CITROËN CARS CORPORATION

INDEX TO SUSPENSION AND HALF AXLES

ANTI-ROLL BAR KNUCKLES

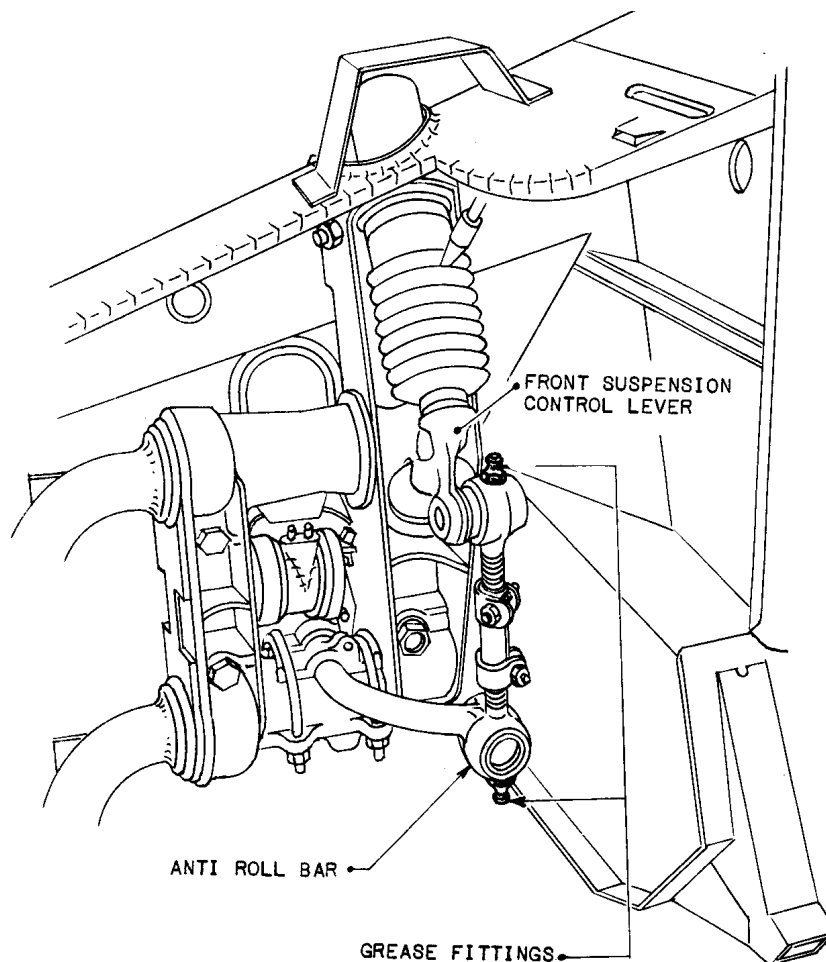
The anti-roll bar knuckles as well as the front suspension control levers are now equipped with grease fittings.

In order to reach these grease fittings it is necessary to remove the front fenders and both upper and lower protection shields (Parts 1# D 434-5; D 434-5A; D 434-106; D 434-107). The greasing of these knuckles must be performed at the 300 mile inspection and thereafter everytime that shields are to be removed. Chassis grease is to be used.

**SERVICE BULLETIN #75
DS - ID - ID 19 STATION WAGON
SHOCK ABSORBERS**

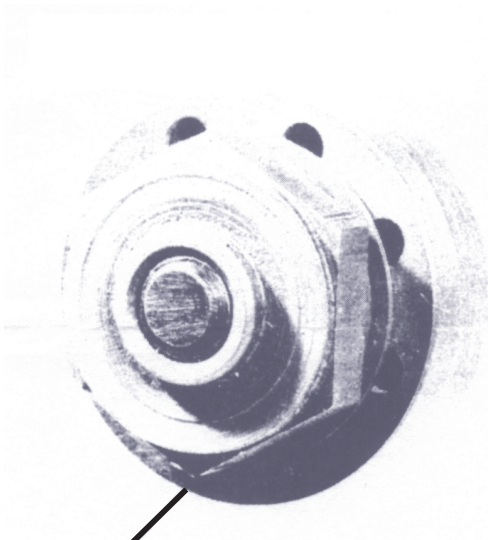
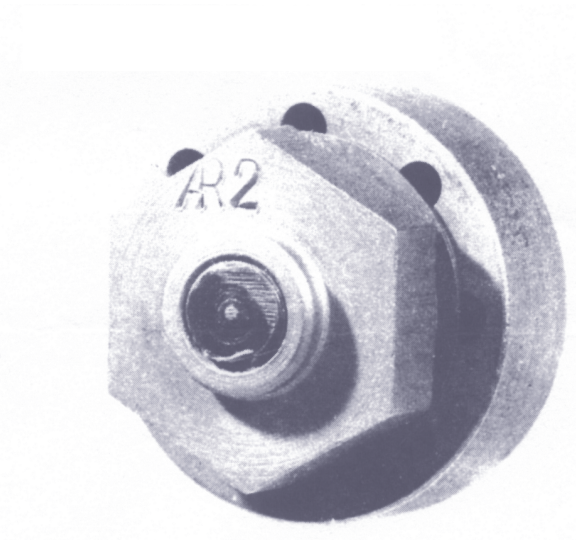
Since January 1962, the reference marks on the shock absorbers are as follows:

1) Front shock absorber ID - DS & ID 19 Station Wagon:

Shoulder on nut facing cylinder

Mark "AR 2" stamped on nut facing cylinder

SHOCK ABSORBERS

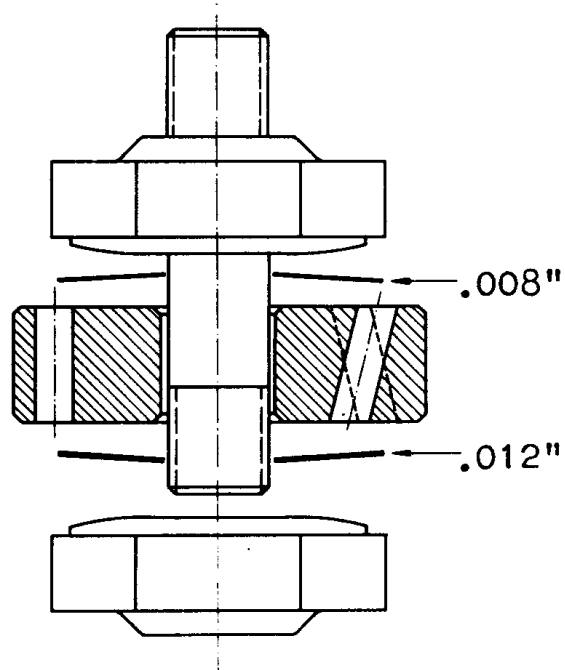
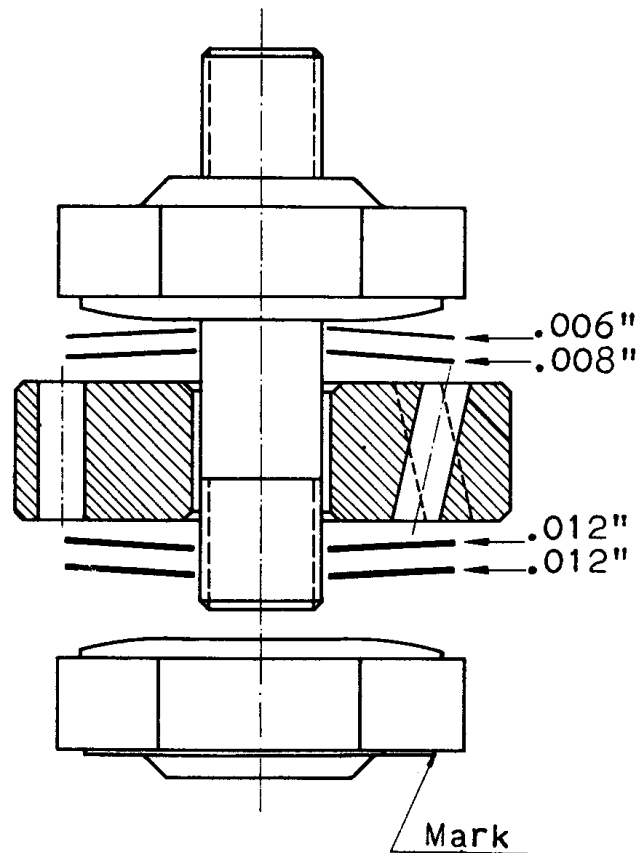
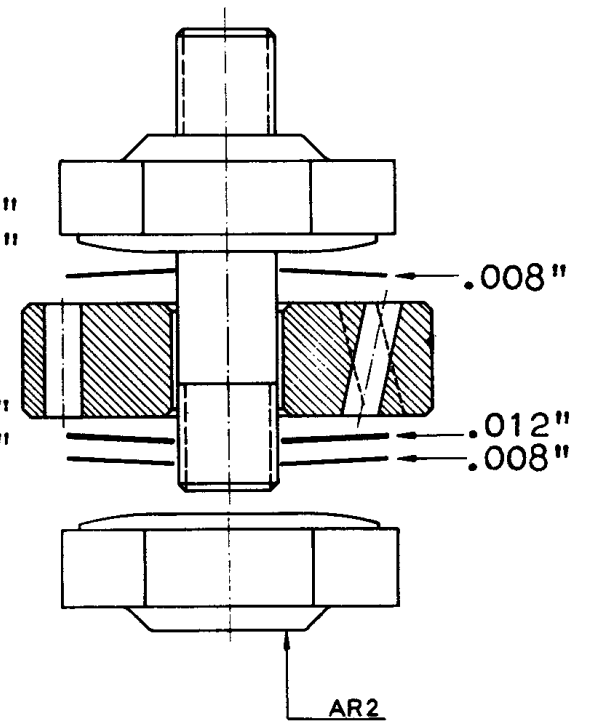
On the cars now leaving our plant, modified shock absorbers are installed. The new shock absorbers have a hole of 0.079" or 2mm on the central body piece parallel to the axis. The flow control shims are of the same thickness as the previous ones except that they are slightly dome shaped. The shims are to be mounted as shown on diagram.

Shims of 0.013" (0.03 mm) are no longer used.

The nuts differ only by their outer bevel.

It is possible to install new shock absorbers instead of the old ones. When installing a new type shock absorber, always change the shock on opposite side, i.e. exemple: if a new type shock is installed on left front, install a new type shock on right front. Same applies to rear.

The tightening torque of the nuts is 14.5 ft/lbs or 2 m/Kgs The tightening torque of the shock absorber assembly on the suspension sphere is 11.5 ft/lbs or 1.6 m/Kgs. It is imperative to respect these torques. The use of a torque wrench is absolutely required.

SUBJECT: SUSPENSION - Shock Absorbers

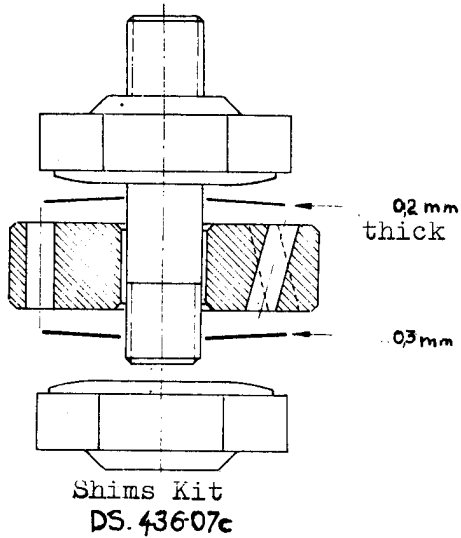
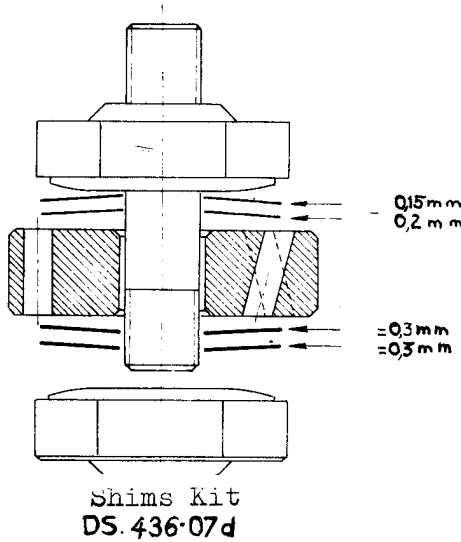
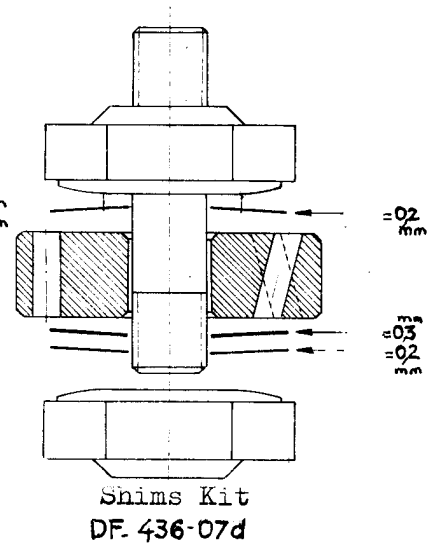
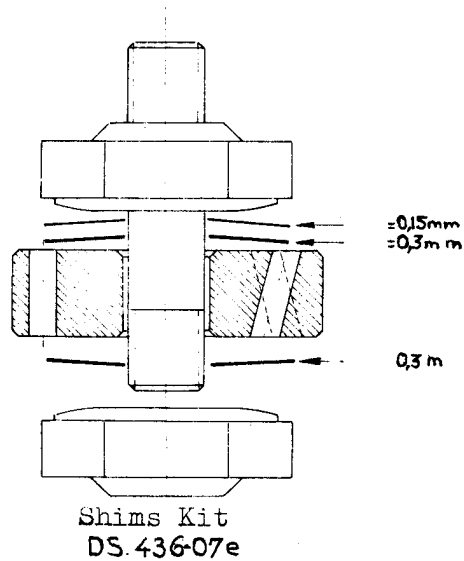
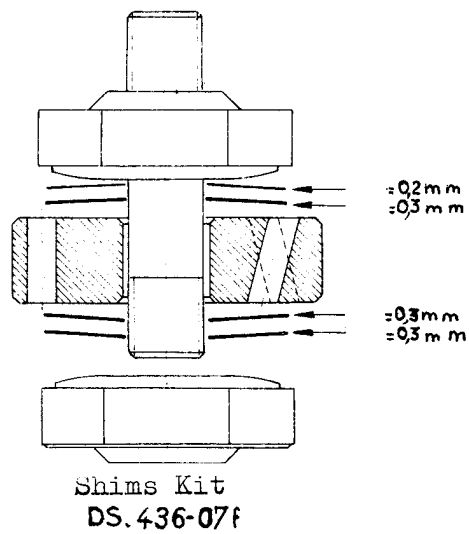
Our Parts Department has now available shock absorber shim kits for normal (original equipment) or heavy duty.

- The shims are bent across a diameter. The concave side **MUST** face the plate. It is not necessary to have the shim center line in the same direction.
- The tightening torque of the cap nuts is 15 ft.lbs.
- Assemble the complete shock absorber to the sphere with 12 ft/lbs of torque.

BOTH FRONT SHOCK ABSORBERS MUST BE ABSOLUTELY IDENTICAL. THE SAME APPLIES TO THE REAR. HOWEVER, THE FRONT ASSEMBLY IS NOT THE SAME AS THE REAR.

Position of the Support Plate

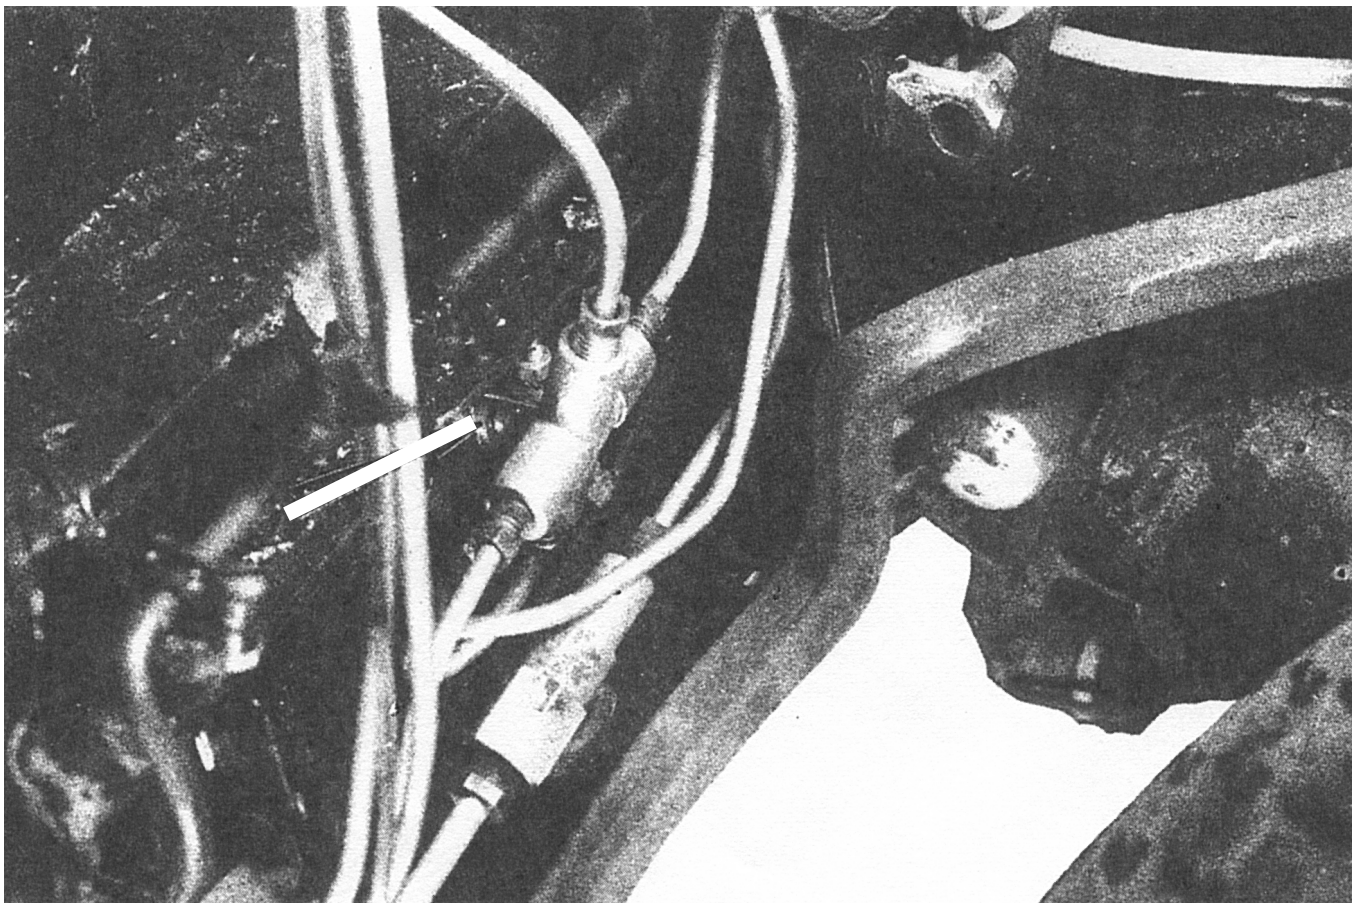
The connecting union of the left rear suspension is modified on the above mentioned models. It is replaced by a new union with "screw-in" connections.

- 1) Connect the union to the hydraulic lines.
- 2) Mount the spring steel support plate of the 3 or 4 way union on the rear unit of the body (see figure). Pierce a hole with a pick and use a self-tapping screw.

SUBJECT: AXLES - Wheel Lugs and Spindles

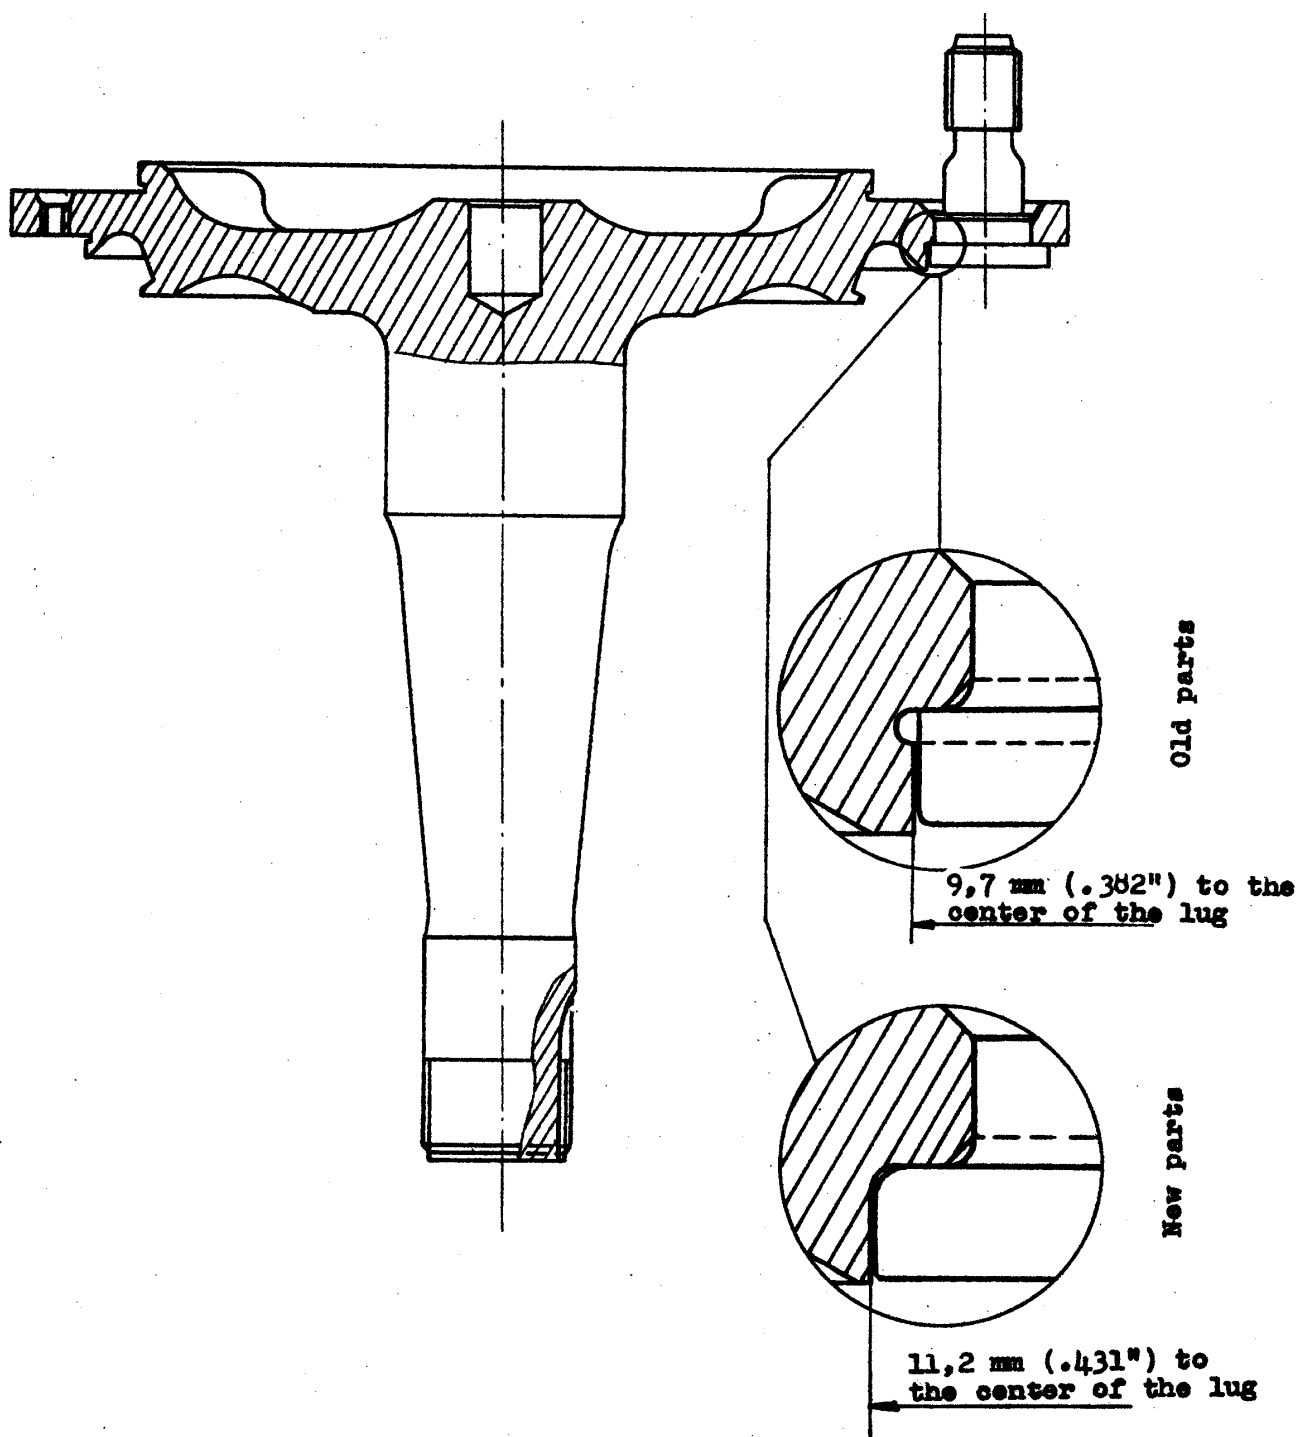
The wheel lugs, rear wheel spindles and hubs of the front pivots are modified.

The assembly of a new wheel lug on an old rear spindle is not possible. The assembly of an old type lug on a new rear spindle is not possible.

- The replacement of a wheel lug on a pivot is not possible. It is necessary to exchange the pivot.

SUBJECT : SUSPENSION - Suspension Cylinders

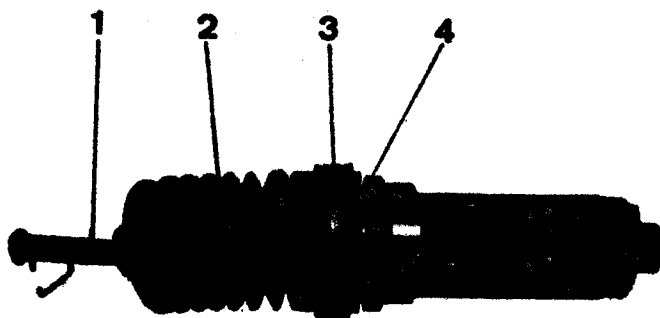
The sealing of the suspension cylinders is now modified. A squared cross-section "O" ring assures the sealing between the body of the cylinder and the interior surface of the nut.

The new suspension cylinders are interchangeable with the old. On an old suspension cylinder where the sealing is made by a teflon "O" ring, it is possible to replace the nut and washer by the new parts: nut, washer, seal ring.

- The "square" ring seal must be set in place in the nut before mounting the nut on the suspension cylinder.
- The tightening torque of the cylinder nut should be 9-12 m/Kg (65-87 ft/lbs).
